Item 3.**Development Application: 132-138 McEvoy Street, Alexandria - D/2018/1615**

File No.: D/2018/1615

Figure 27: McEvoy Street setback. The red hatched area shows the land to be dedicated which is 1.4 metres in width and has a total area of 108 square metres.

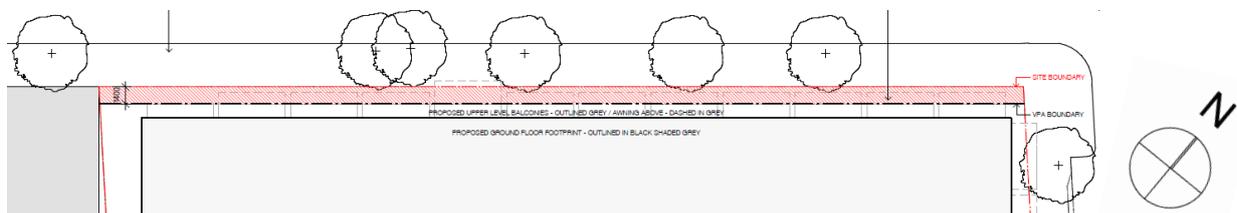
64. The applicant has incorporated this setback to McEvoy Street in the current proposal (as indicated in Figure 27 below). The 108 square metres of land along the McEvoy Street frontage has been included in the public benefit offer to dedicate this land for the shared path widening.

Figure 28: Facade section and plan details showing fixed horizontal and vertical shading.

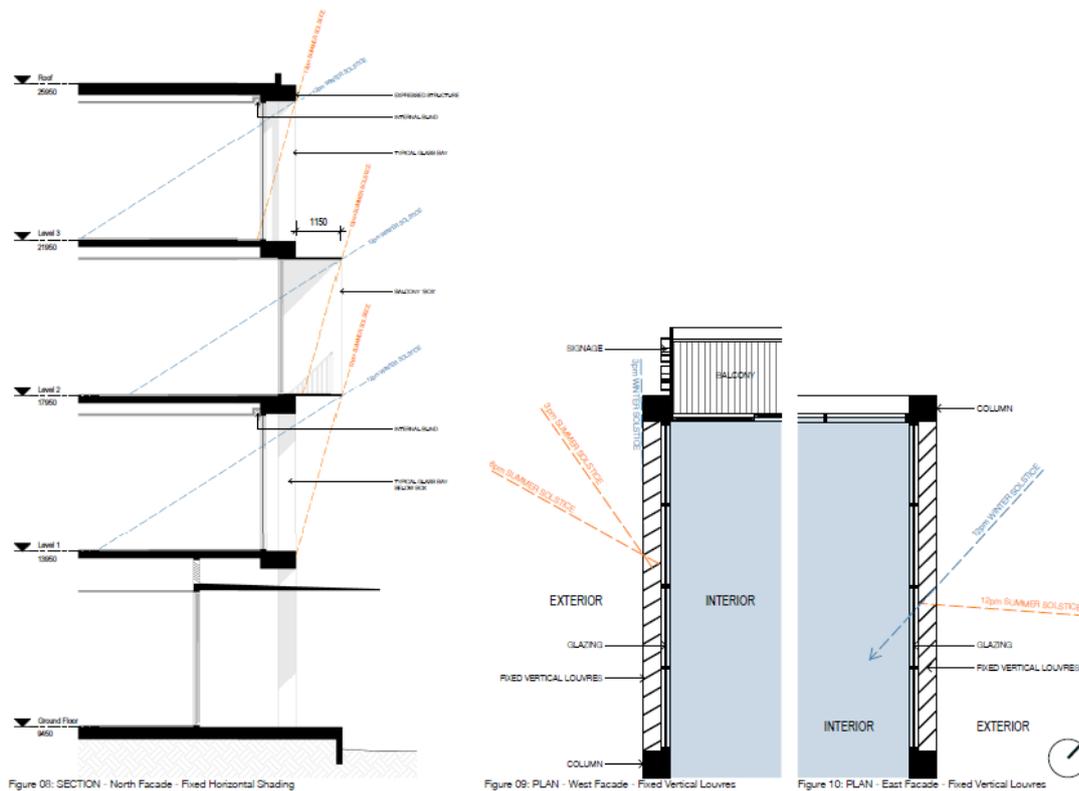
68. The north facade section drawings submitted with the amended application show that the uppermost level is affected by the midsummer midday sun (as indicated in Figure 28 below).

69. As this detail relates to the McEvoy Street facade, passive shading must be provided to respond to the north-west orientation of the building, including the provision of adjustable, vertical louvres to deal with low altitude sunlight in the afternoon, rather than just at midday. Similarly, the south eastern elevation, which is provided with substantial glazing has no protection from low altitude early morning sunlight.
70. In order to address this, a deferred commencement design modification condition is recommended to ensure additional operable shading is provided to the north-western, north-eastern and south-eastern elevations of the development.

Figure 29: Deep soil plan showing compliant deep soil hatched in green, undercroft deep soil area hatched in blue, overall deep soil in light green and the requisite area for compliance hatched in red.

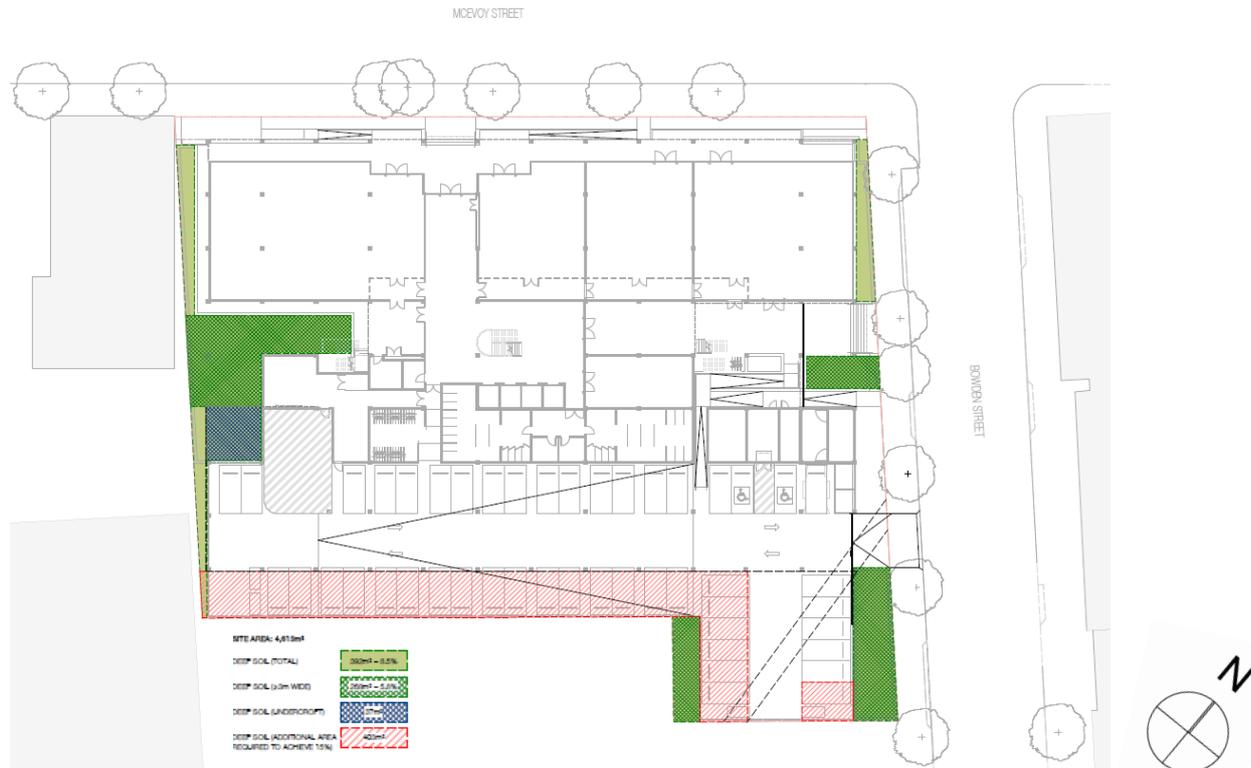
71. The relevant provisions in Section 5.8.2.5.1 of the Sydney DCP 2012 require deep soil to be provided to a minimum of 15% (691.5 square metres) of the site area, where sites are located in the B6 Enterprise Corridor zone, with a minimum dimension of 3 metres.
72. The proposal provides 5.8% (268 square metres) of the site area as deep soil which has a dimension of more than 3 metres. An additional 1.9% (87 square metres) is provided on site, which has a dimension of less than 3 metres. An area of 0.1% (37 square metres) is also located in an undercroft area (as indicated in Figure 29 below).
73. It is considered that there is an opportunity for the proposal to meet the objective of the above control in Section 5.8.2.5(a) of the Sydney DCP 2012 by enhancing visual amenity through the provision of a green roof and high quality landscaped setbacks along the southern boundary of the site.

74. The proposal is acceptable in this respect, subject to a deferred commencement design modification condition to ensure that a green roof is provided over the northern wing of the building, that additional deep soil areas and tree plantings are provided in between the proposed car parking spaces along the southern edge of the site, and that the parking spaces within the setback area are provided with permeable paving.
